OPEN SPACE AND INDIGENOUS VEGETATION
ESTERO GOLF RESORT
 March 21, 2001

DCI 2000-00032

RE: ESTERO GOLF RESORT
DCI2000-00032
SUFFICIENCY COMMENTS

FIGURE: 3

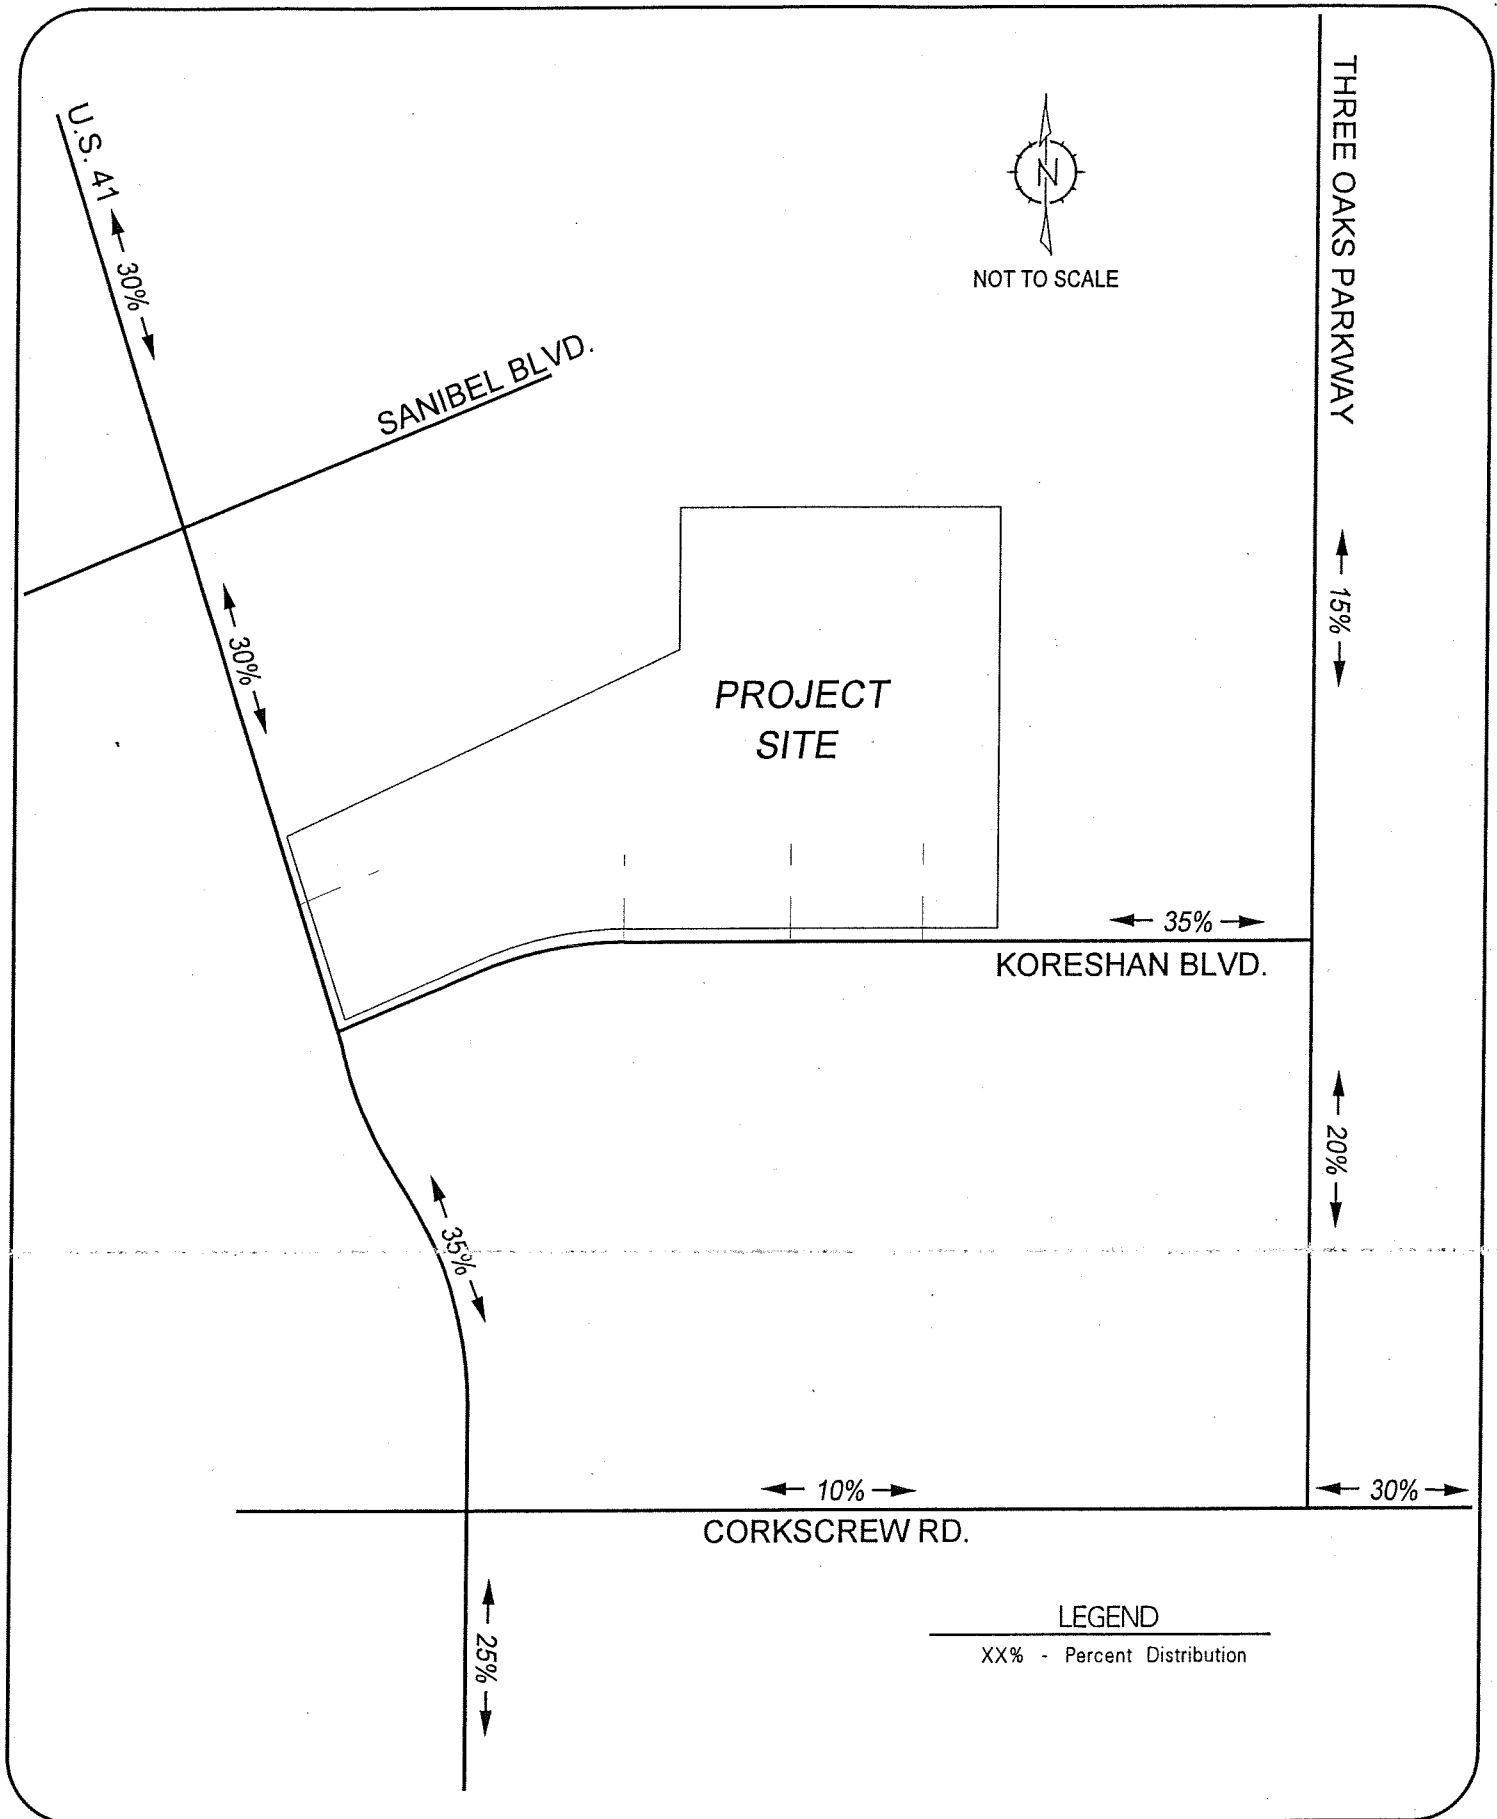
4) & 5) Table 2-A, the Percent Project Traffic distribution on Koreshan Boulevard doesn't match what is shown on Figure 3. The data for the two segments of Three Oaks Parkway appears to be reversed. This will also affect Table 1-A and Figure 6.

- 4)&5) **Table 2-A**, the PERCENT PROJECT TRAFFIC distribution on Koreshan Blvd. doesn't match what is shown on Figure 3.

- 4)&5) **Table 2-A**, the PERCENT PROJECT TRAFFIC distribution on Koreshan Blvd. doesn't match what is shown on Figure 3.
The data for the two segments of Three Oaks Pkwy. appears to be reversed.
This will also affect **Table 1-A** and **Figure 6**.

FIGURE: 4

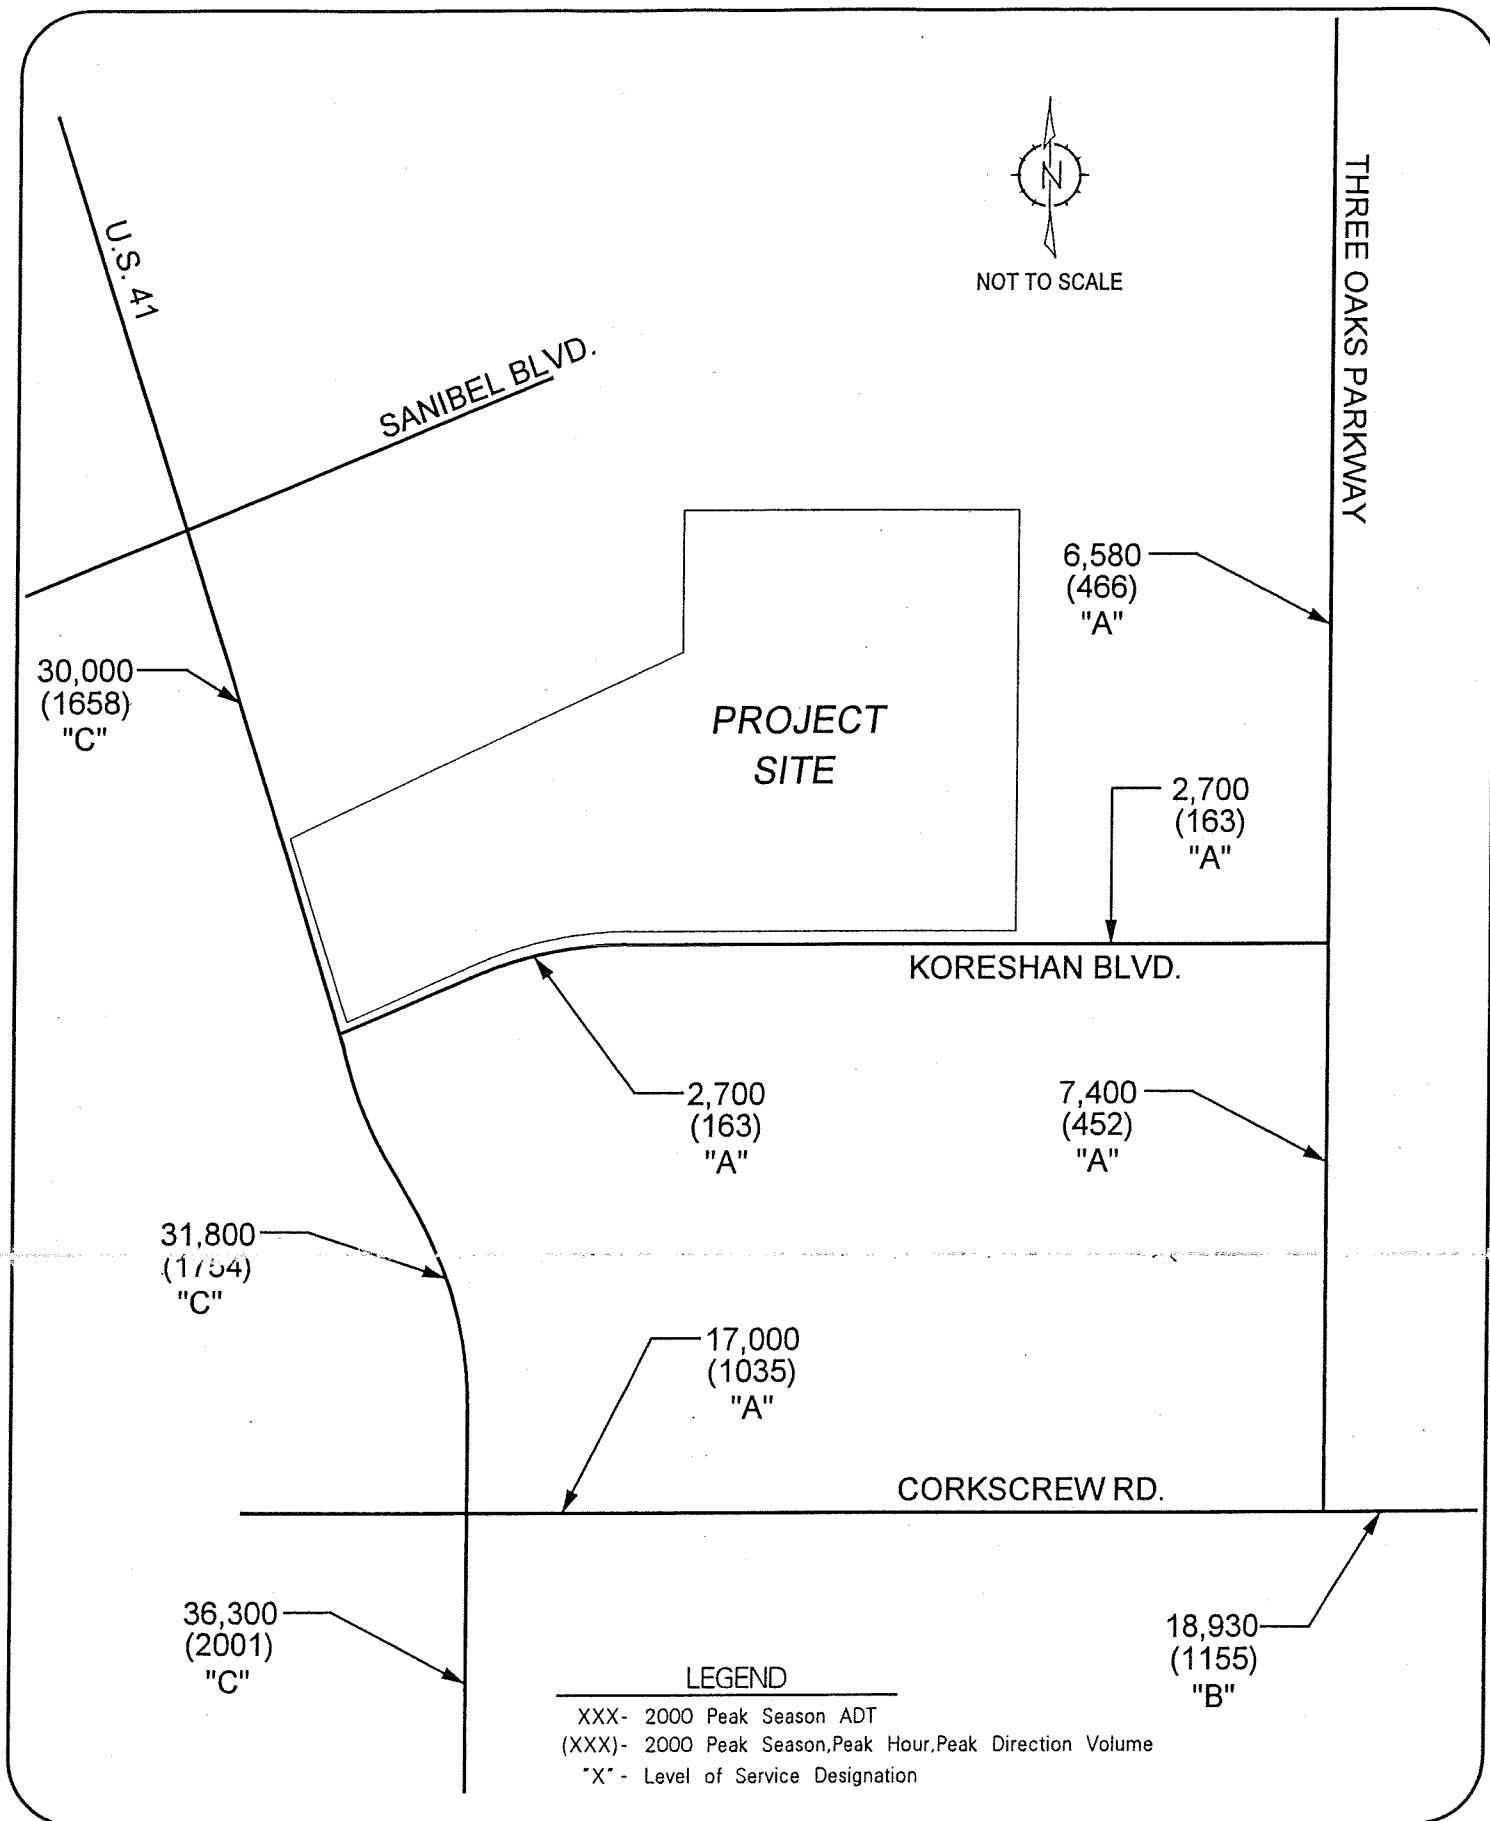
- 2) *The equation, instead of the average rate, should have been used to calculate the PM peak hour trip generation for General Office (LUC 710). This will result in a somewhat higher volume than shown, which will also affect some data in Table 1-A, Table 2-A, Table 5 and Figure 4.*

The equation, instead of the average rate, should have been used to calculate the PM peak hour trip generation for General Office (LUC 710). This will result in a somewhat higher volume than shown, which will also affect some of the data in **Table 1-A**, **Table 2-A**, **Table 5**, Figure 4.

The equation, instead of the average rate, should have been used to calculate the PM peak hour trip generation for General Office (LUC 710). This will result in a somewhat higher volume than shown, which will also affect some of the data in **Table 1-A**, **Table 2-A**, **Table 5**, Figure 4.
